Nos. 110-114 Herring Road, Macquarie Park

Section 75W Modification to MP10_0112 and
MP10_0113

August 2014

FIGURE 5 – LANDSCAPE MASTER PLAN

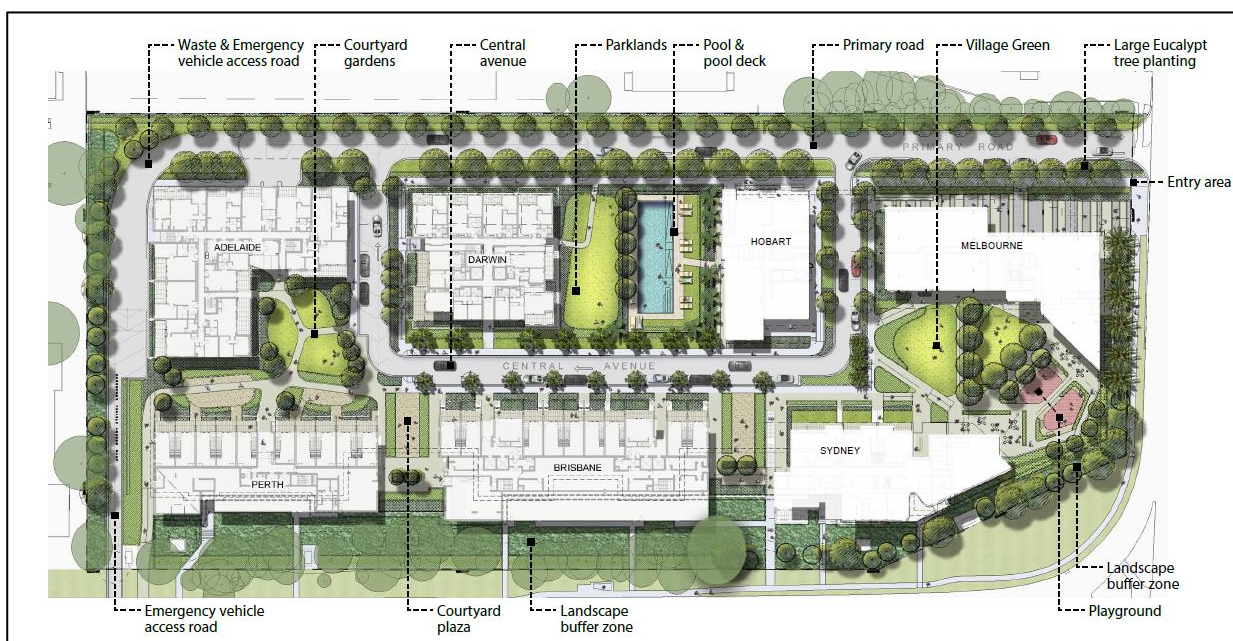
The landscaping is proposed to be modified as a result of design development and changes to the road network and loading dock (subject of Section 75W MOD 3 which is currently under assessment). The approved and proposed landscape designs are compared in Figure 5 below. The key changes to the landscape design include:

- Removal of trees along the western elevation of Adelaide to accommodate the approved road network, with the roadway and loading dock now on the western side of the Adelaide and Perth Buildings, respectively;
- Changes to the pathways and plantings around the swimming pool. High shrub planting at the edges will provide privacy to the pool from adjacent dwellings;
- Evergreen trees and a planted pergola and seating adjacent the pool will create a sheltered and partly shaded area and privacy from the dwellings above;
- Changes to the street trees along the central avenue, with low-medium level planting in raised planters. The plantings will accentuate the east-west alignment of Central Avenue;
- Changes are proposed to the Village Green and Play areas;
- Changes to pathways and open space areas throughout the site.
